6559 - 15th AVENUE NW

Subject: Early Design Guidance
Property: 6559 15th Ave NW
Project Number: 3011448
Date: August 23, 2010

D-7 Personal Safety and Security

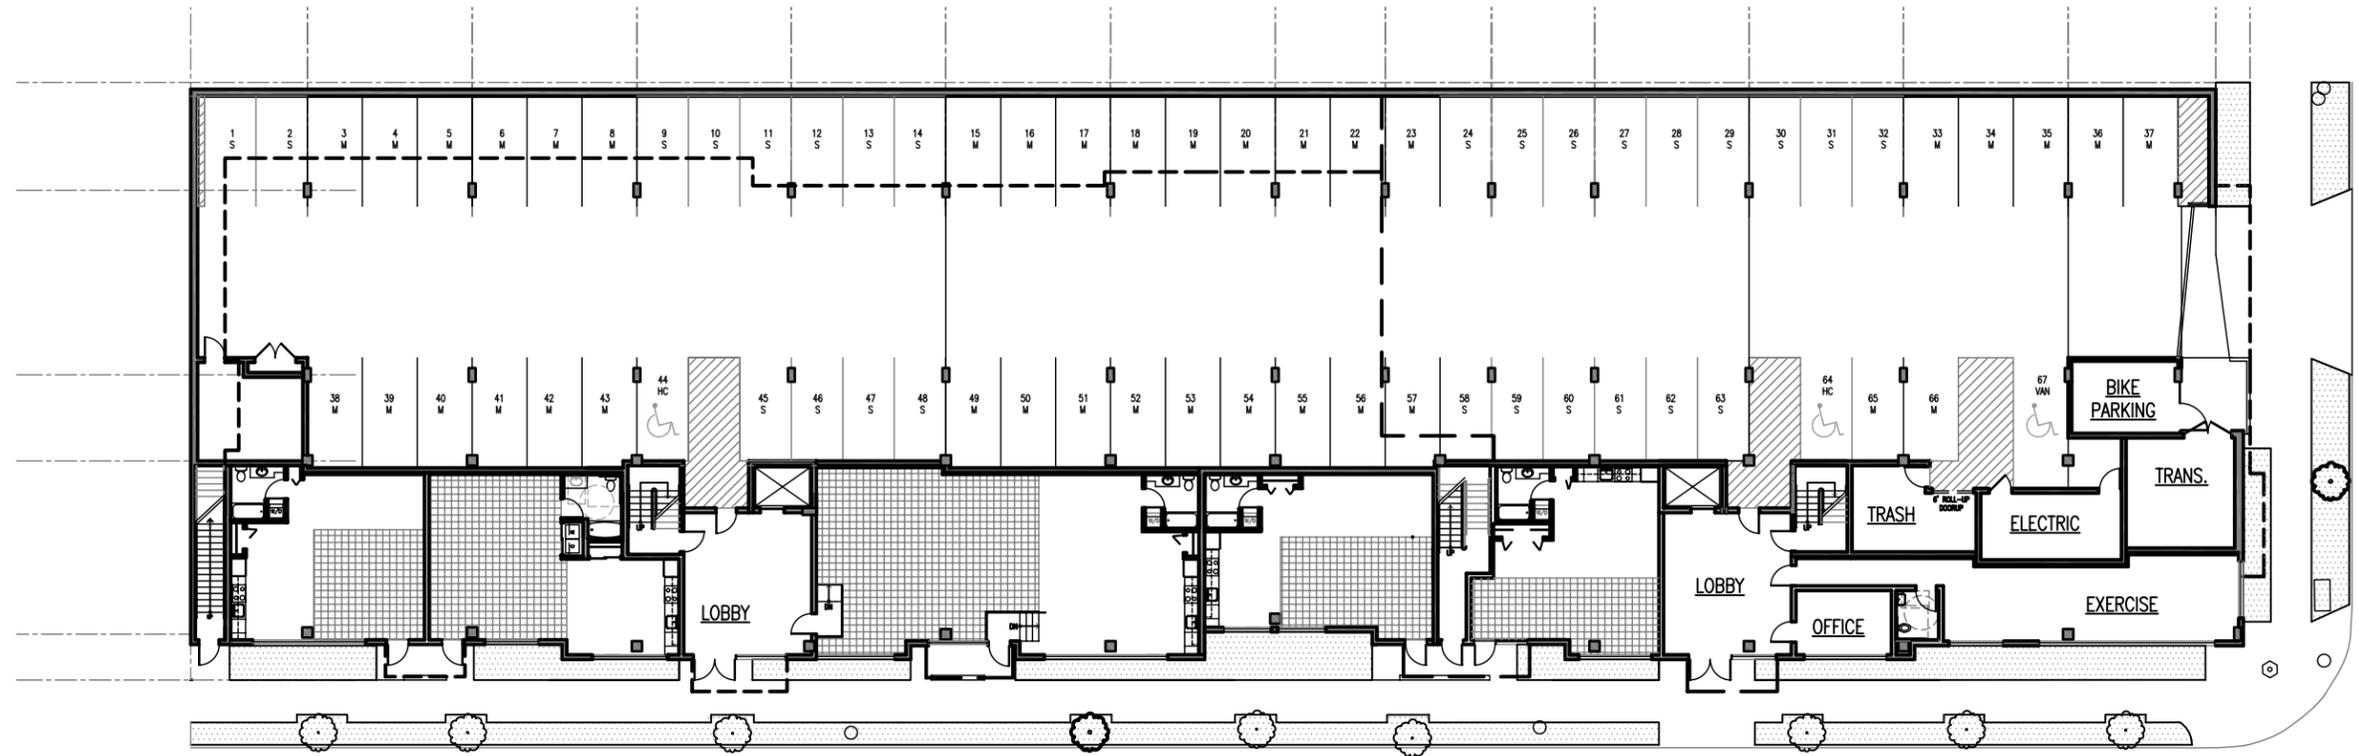
“The surface of the driveway out of the parking garage should have a feature incorporated into it which signals to exiting motorists that they are entering the pedestrian realm and need to exercise caution.”

Response; The garage entry has been pulled back from the property line to give motorists plenty of room to see pedestrians. We have also added scoring to the concrete that signals they are in a pedestrian zone. In addition we are going to paint the north side of the bike parking wall with a mural that signals bicycles in this zone. There is also an ornamental gate shown at the bicycle parking. Please see Site plan and North Elevation.

GROUND LEVEL

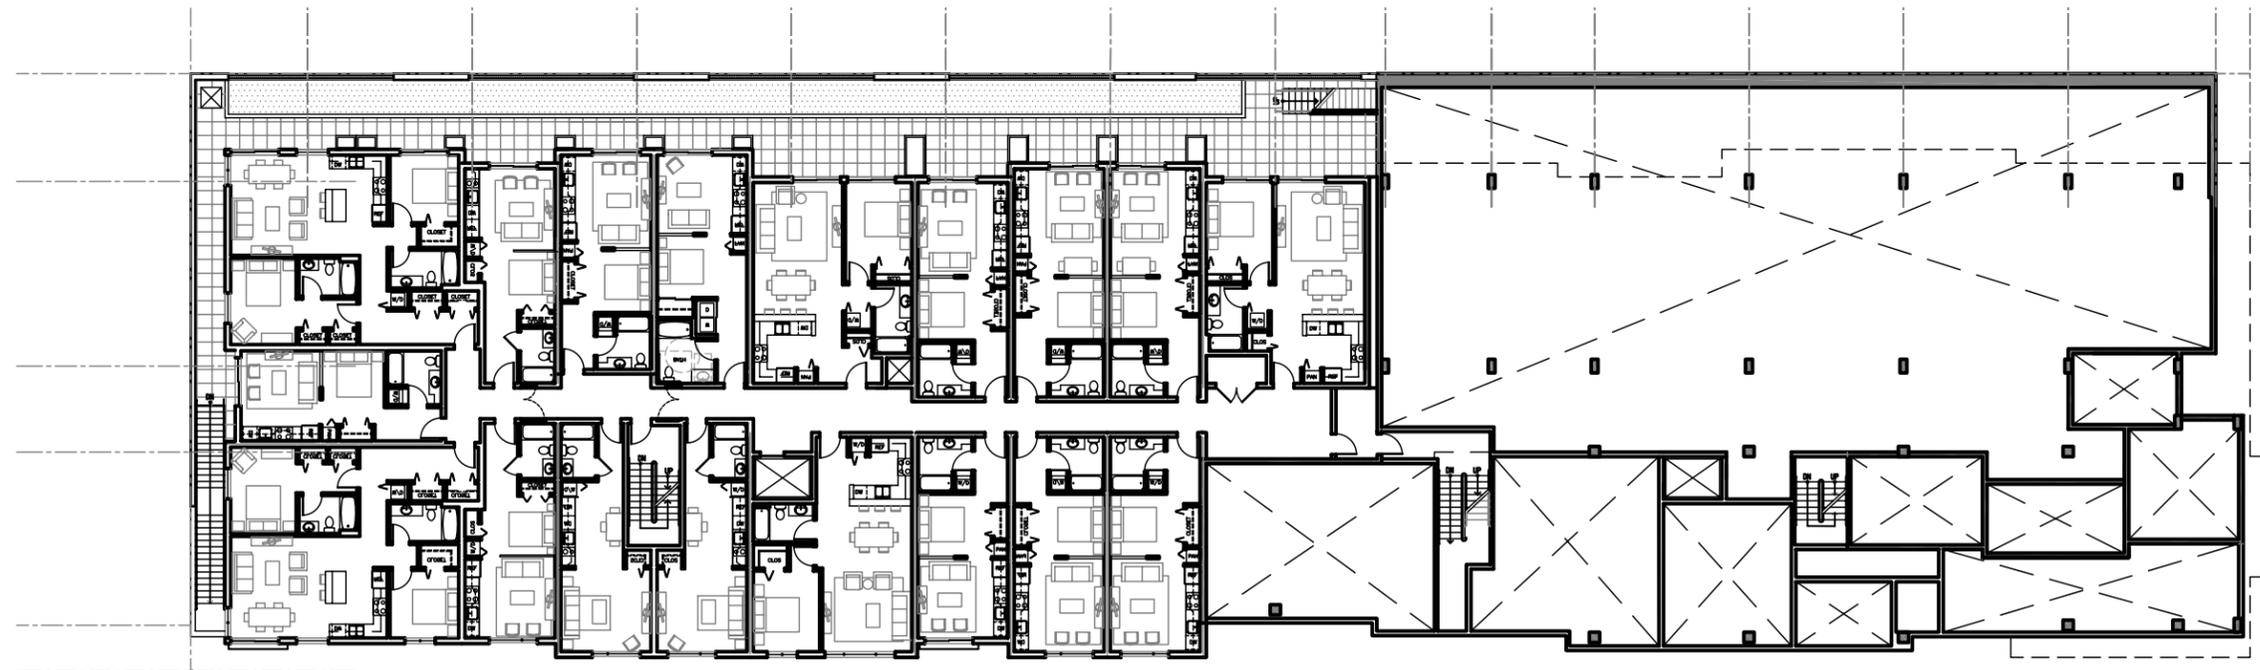
“Over head weather protection along sidewalks is highly encouraged. Such a canopy along the length of the 15th Ave NW frontage is encouraged.”

Response; The building is set back from the property line four feet so a continuous canopy would not provide weather protection at the sidewalk. So, individual canopies have been provided at all the building entries and live/work entries. Please see Section at Live/work entries and Ground floor plan.

LOOKING EAST FROM NEIGHBOR'S REAR YARD

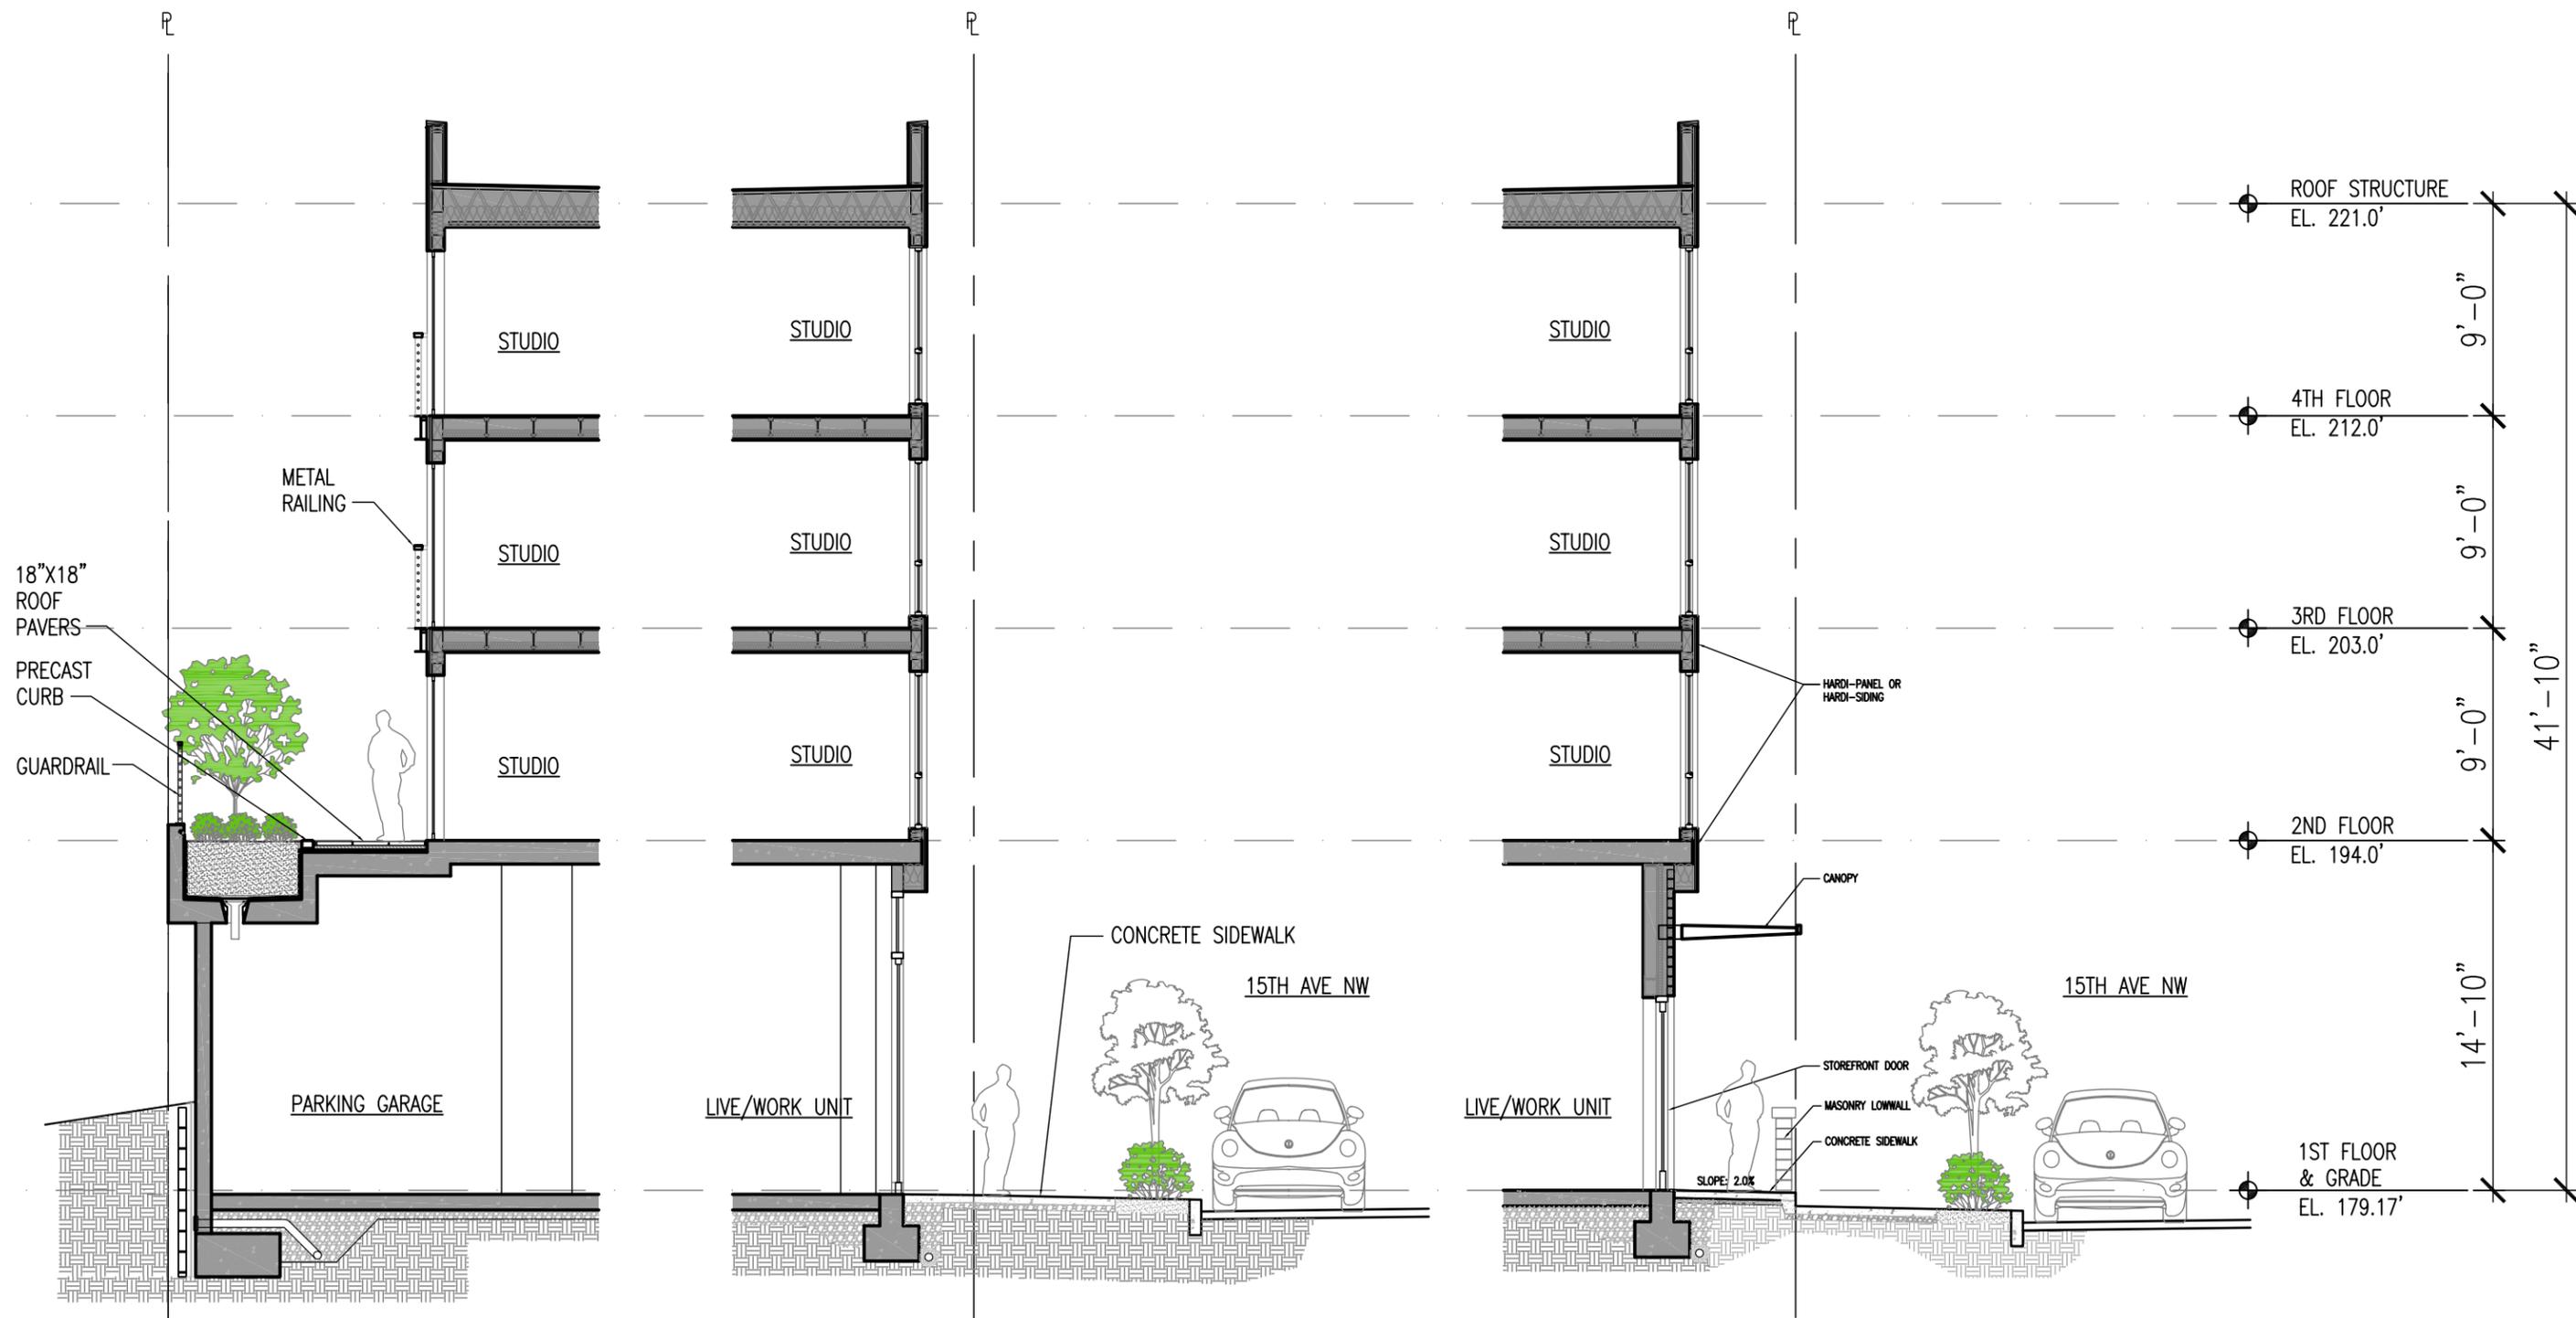
"Along the rear property line, the site sits above the rear yards of single family houses to the west. The cement wall of a parking garage along this line needs to be designed to lessen the blankness of the wall which may be as high as 13 feet above grade."

Response; The project has incorporated a green screen railing that is broken regularly by the concrete wall. The landscape is designed to grow up and over the green screen. The concrete wall has joints that have been added to lessen the blankness and the lower section of the wall is recessed to create shadow. Please see East Elevation and Sections.

SIGNAGE

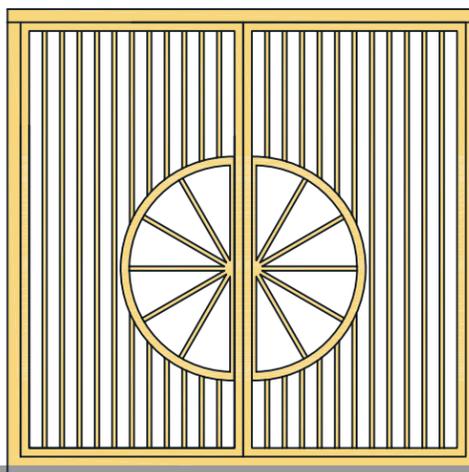
A-2 Streetscape compatibility (cont.) The location and form of potential signage on the building should be developed and incorporated into the architecture.

Response; The project currently does not have a name but a unlit blade sign is located near the corner of NW67th and 15th Ave NW. A signage permit will be submitted at a later date. Please see rendering at the Northeast corner.
